SUBJECT: ISSUANCE OF AMENDMENT (TAC NO. 68360)

The Commission has issued the enclosed Amendment No. 139 to Facility Operating License No. DPR-65 for Millstone Nuclear Power Station, Unit No. 2, in response to your applications dated November 15, 1988 and February 1, 1989.

This amendment allows operation of Millstone Unit 2 for Cycle 10. The changes to the Technical Specifications reflect a revised safety analysis that includes the use of fuel designed and fabricated by Advanced Nuclear Fuels Corporation. Fuel designed and fabricated by ANF has not been previously utilized for Millstone Unit 2. The changes to the Technical Specifications also reflect the effects of reduced reactor coolant flow from 340,000 to 325,000 gpm.

NORTHEAST NUCLEAR ENERGY COMPANY  
THE CONNECTICUT LIGHT AND POWER COMPANY  
THE WESTERN MASSACHUSETTS ELECTRIC COMPANY  
DOCKET NO. 50-336  
MILLSTONE NUCLEAR POWER STATION, UNIT NO. 2  
AMENDMENT TO FACILITY OPERATING LICENSE

FIGURE 2.1-1 REACTOR CORE THERMAL MARGIN SAFETY LIMIT - FOUR REACTOR COOLANT PUMPS OPERATING

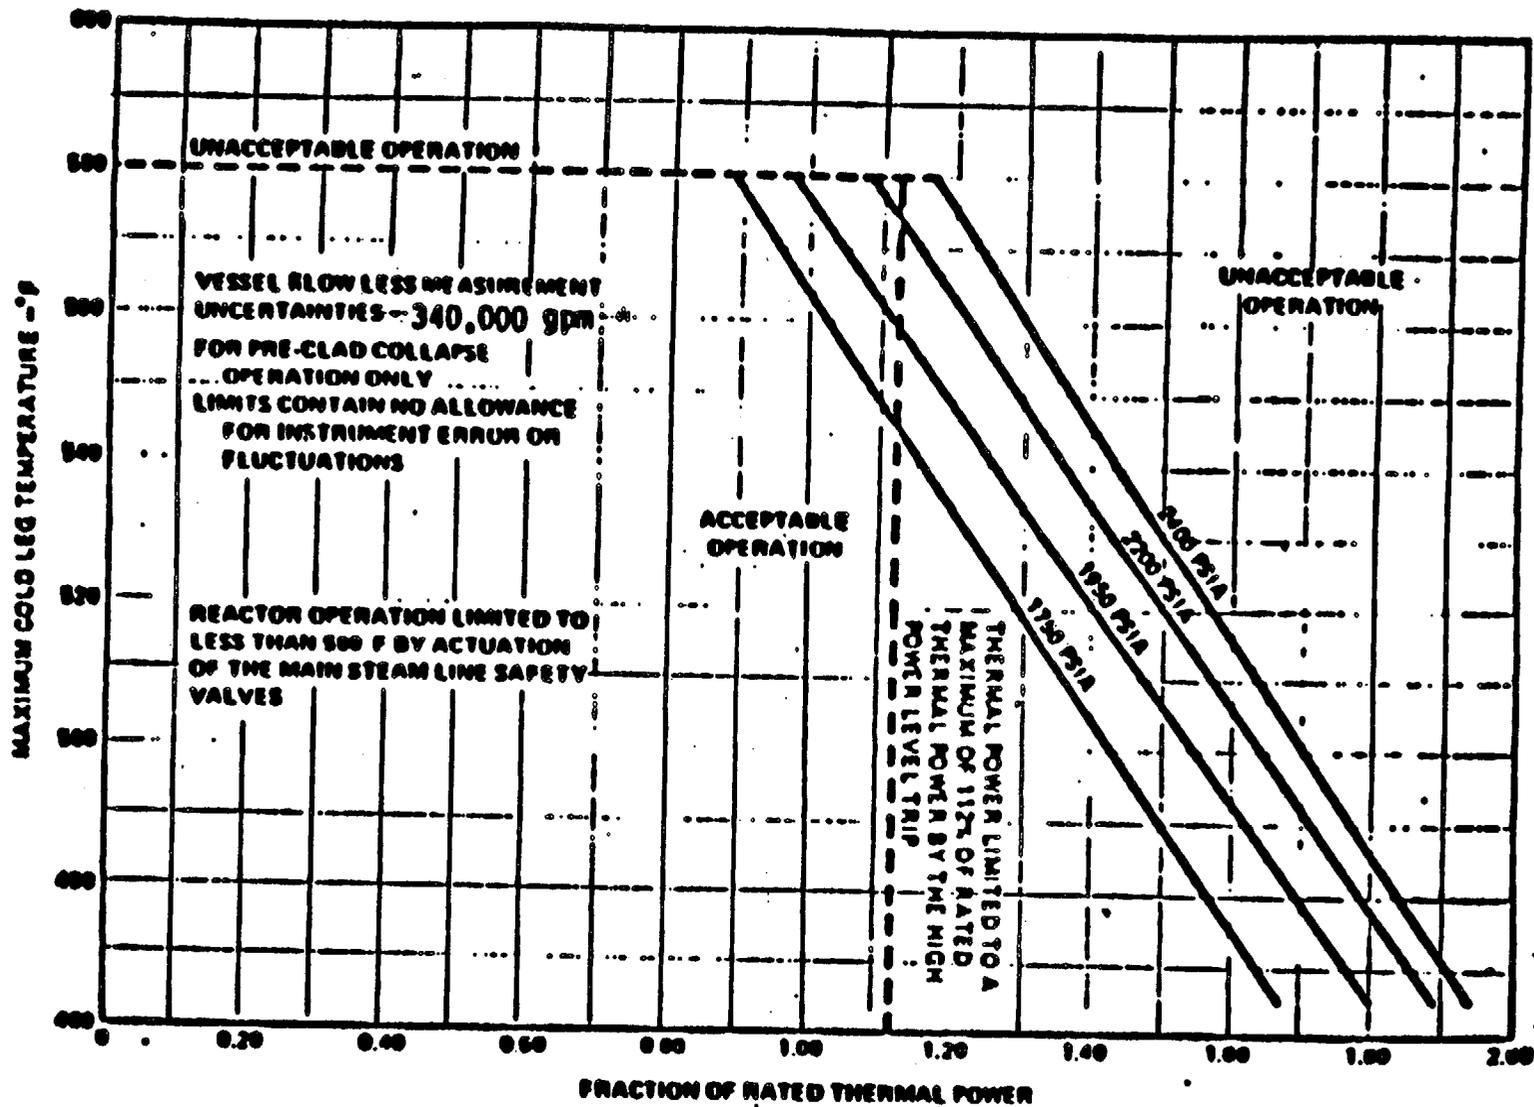
2. Page 1-5 of the definitions - Deletes the definition for  $F_{xy}$  because  $F_{xy}$  is being removed from the Technical Specifications.
3. Section 2.1.1 (Figure 2-2 on page 2-2) - A footnote is added to specify the minimum reactor vessel flow of 325,000 gpm for the case with the reduced  $Fr$  as specified in Technical Specification 3.2.3. This change is consistent with the assumptions used in the acceptable analytical results (Ref. 30) and is acceptable.

\*Flow<sub>T</sub> reductions, to 325,000 gpm are compensated for by reductions in the F<sub>r</sub> limit (Specification 3.2.3)

FIGURE 3.2-2 AXIAL SHAPE INDEX vs. FRACTION OF ALLOWABLE POWER LEVEL

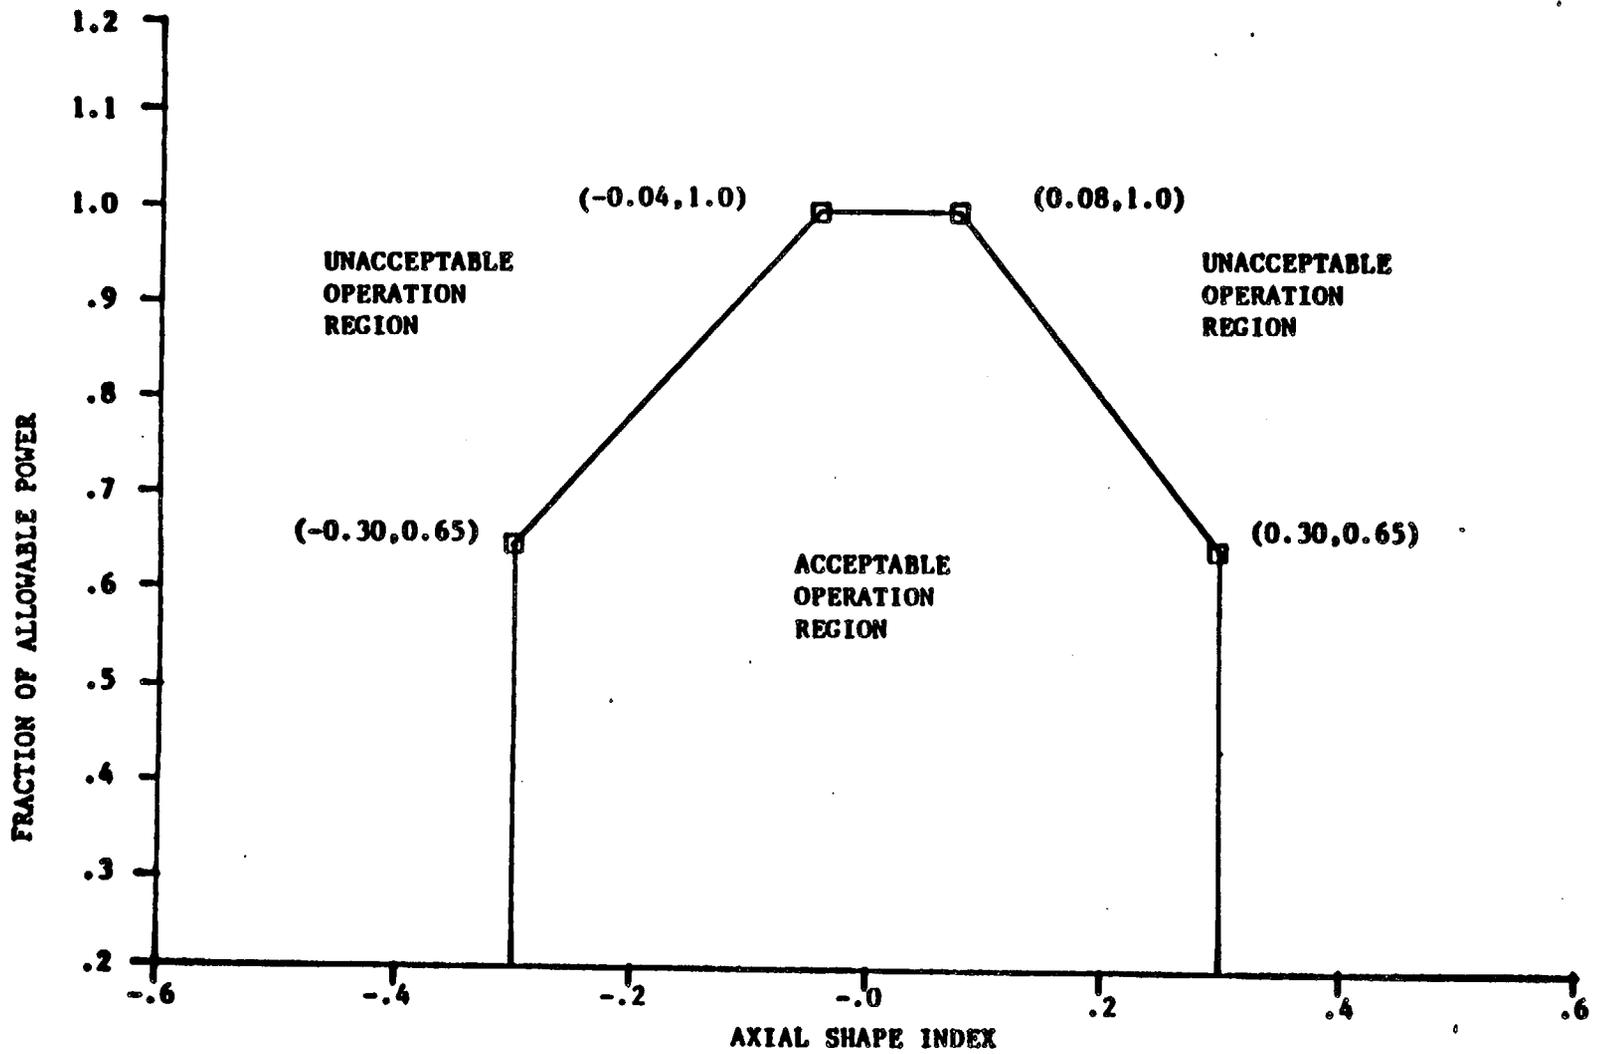
The LHR and the ASI requirements for monitoring of the LHR on Figure 3.2-2a are retained. Figure 3.2-2a is renumbered as 3.2-2 (Ref. 29). Figure 3.2-2b is deleted from the Technical Specification. The changes are consistent with the assumptions used for LOCA (Refs. 9 & 30) and set-point analyses and are acceptable.

FIGURE 4.2.1 Augmentation Factor vs. Distance from Bottom of Core  
(only applicable to fuel batches "A" through "L")

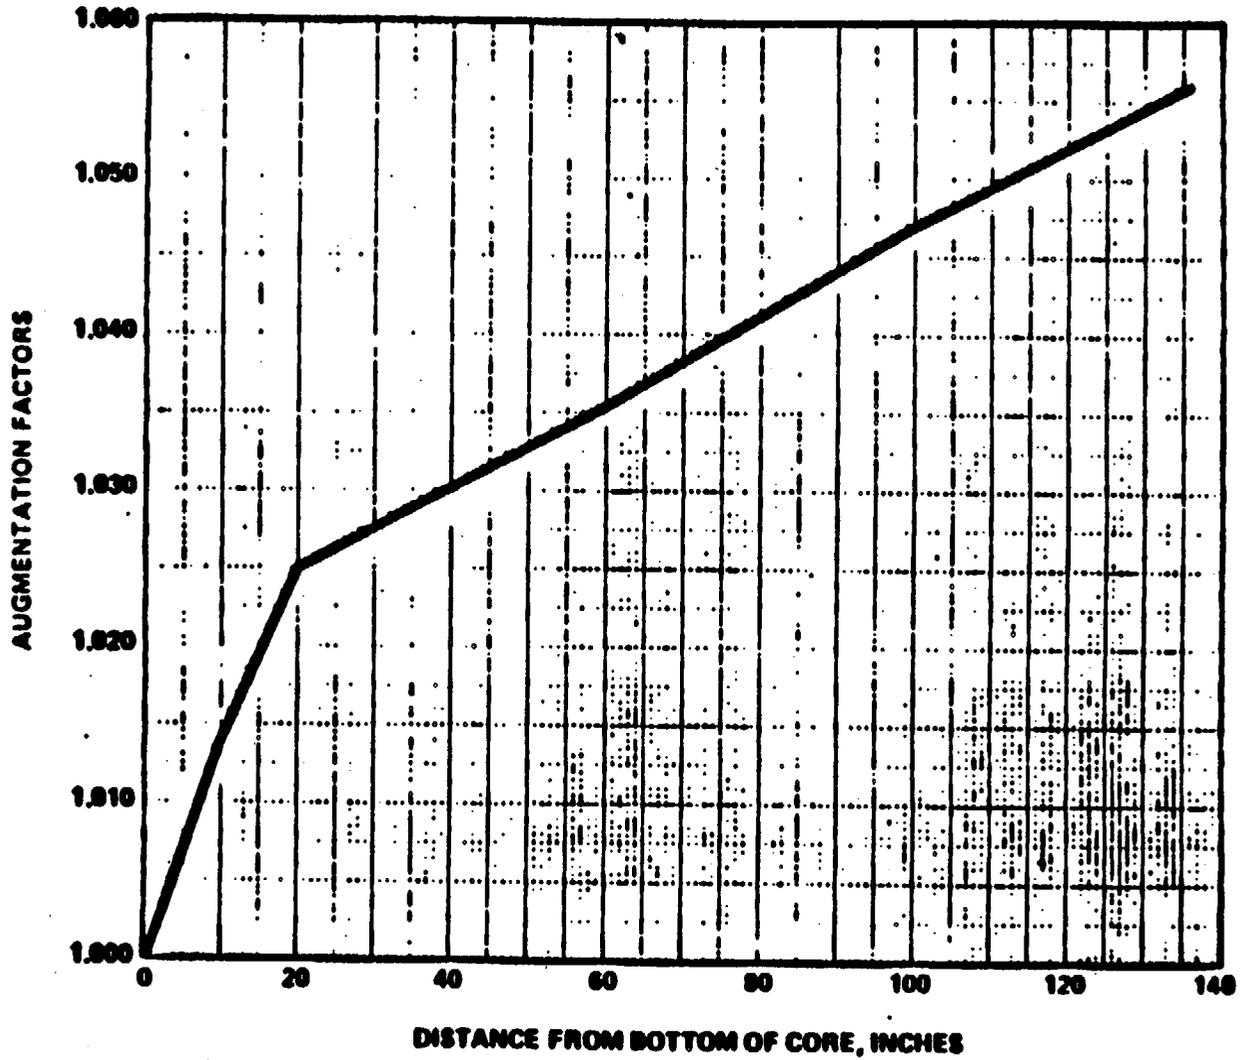
10. Section 4.2.1.3 (page 3/4 2-2) - Deletes two penalty factors. They are (1) Item 4.2.1.3.b.1, the flux peaking augmentation factor as shown in Figure 4.2-1 and (2) Item 4.2.1.3.b.4, the LHR uncertainty factor of 1.01 due to axial fuel densification and thermal expansion. Based on the following reasons, we find the deletions acceptable.

The removal of these penalties only applies to the ANF fuel. They should still be applied to the Westinghouse and Combustion Engineering fuel when used in the core. Therefore, footnote is applied to these two factors (Item 4.2.1.3.b.1 and 4.2.1.3.b.4 on page 3/4 2-2) specifying that they only apply to the non-ANF fuel. This footnote is also added to Figure 4.2-1 (page 3/4 2-4).
